**Addendum #1****NJSDA EMERGENT PROJECT:**

Wilson Elementary School
Water Infiltration Repairs
19 Wilson Avenue
Newark, NJ
NJSDA Project No. #EP-0077-C01

Addendum No.1

DRAWING TITLE:	THIS NO.
WINDOW TYPES (VENT, HOPPER, FIXED)	A1.6
SCALE:	DATE:
1/4" = 1'-0"	5.7.12
	6.14.12

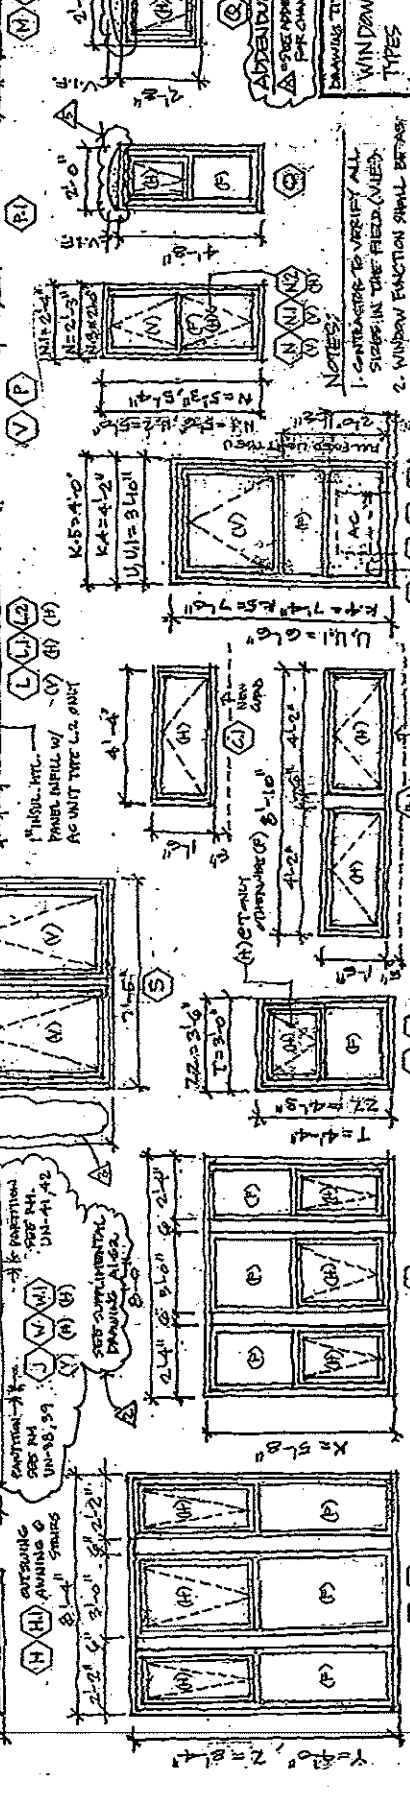
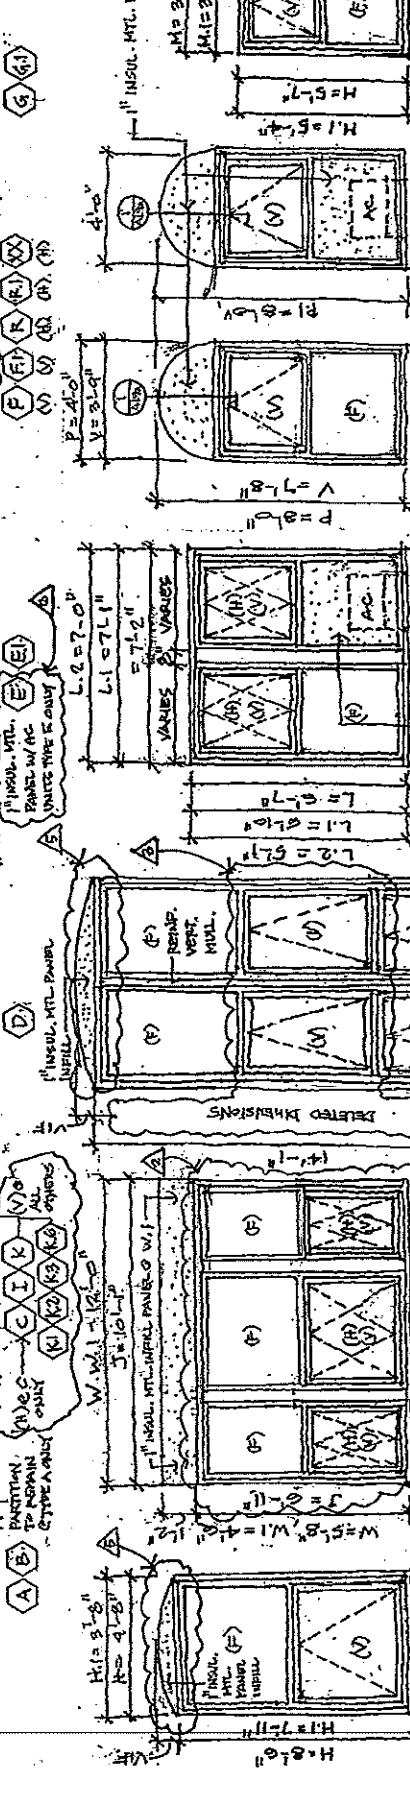
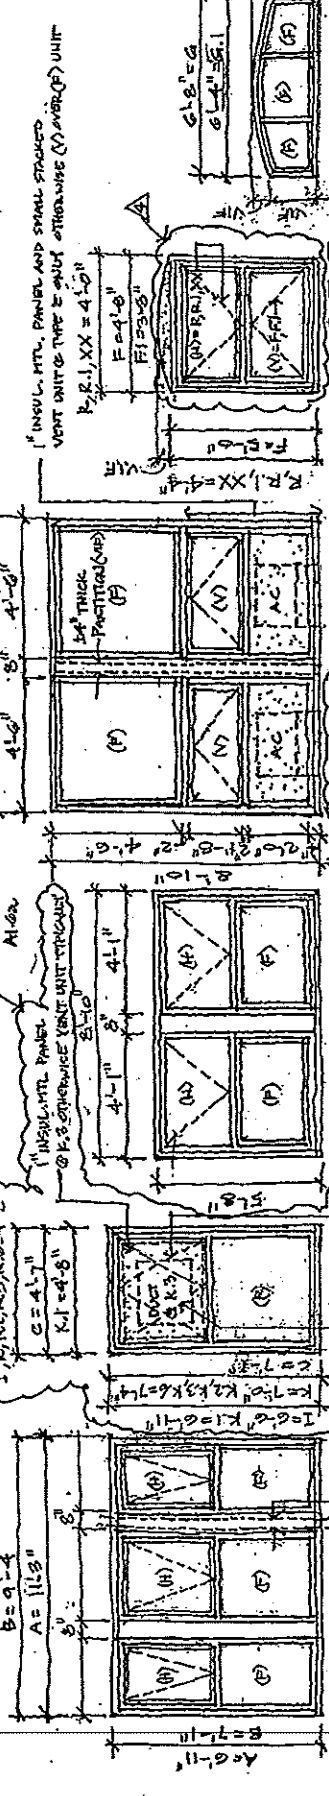
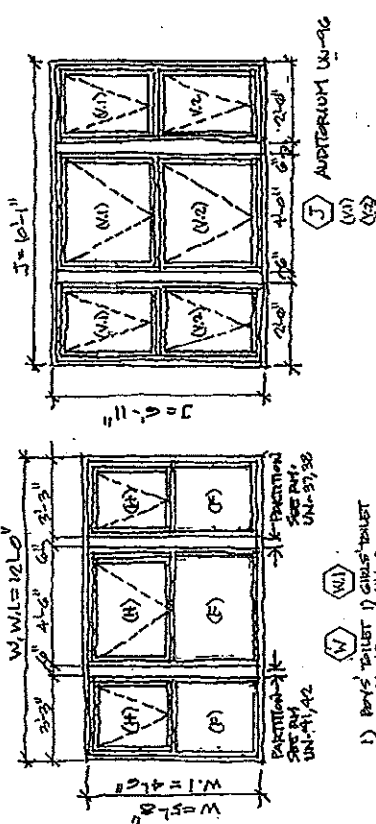
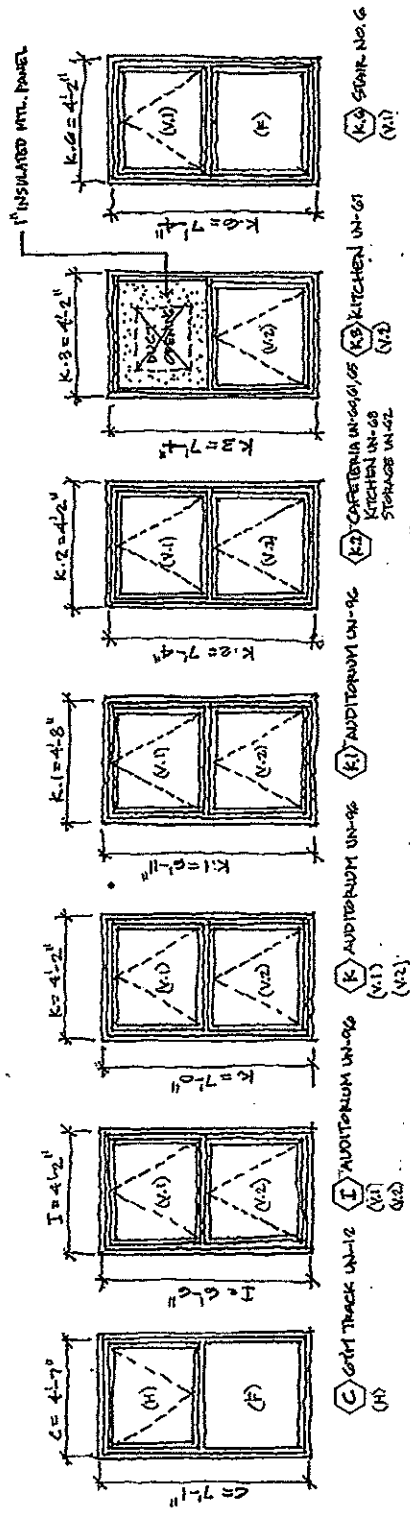
(Items listed below are tagged on drawing A1.6 with item numbers in triangles and the following clarifications explain why they have been tagged and or why a window type illustration has been relocated to drawing A6.1a as follows:)

This item clarifies window types C, I, K, K.1, K.2, K.3 and J which have been amended on drawing A1.6a. They have been amended to include additional ventilation in the Auditorium, Cafeteria, and Kitchen by modifying the stops in the windows. In addition, a note has been added to clarify which windows have 5" limit stops and which windows units are unrestricted without limit stops.

This item refers to the clarification that window type S had its vertical dimension removed and a two vent unit is added for additional ventilation.

This item refers to the clarification that window unit types XX, R and R.1 shall have their hopper units moved from the lower restricted opening to the upper part of the window.

This item refers to the clarification that all curved infill heads shall be detailed where possible similar to detail A1.9a.

This item refers to the fact that only window type E will have AC units installed in 1" insulated panels; type E.1 shall have 1" insulated panels without AC units.
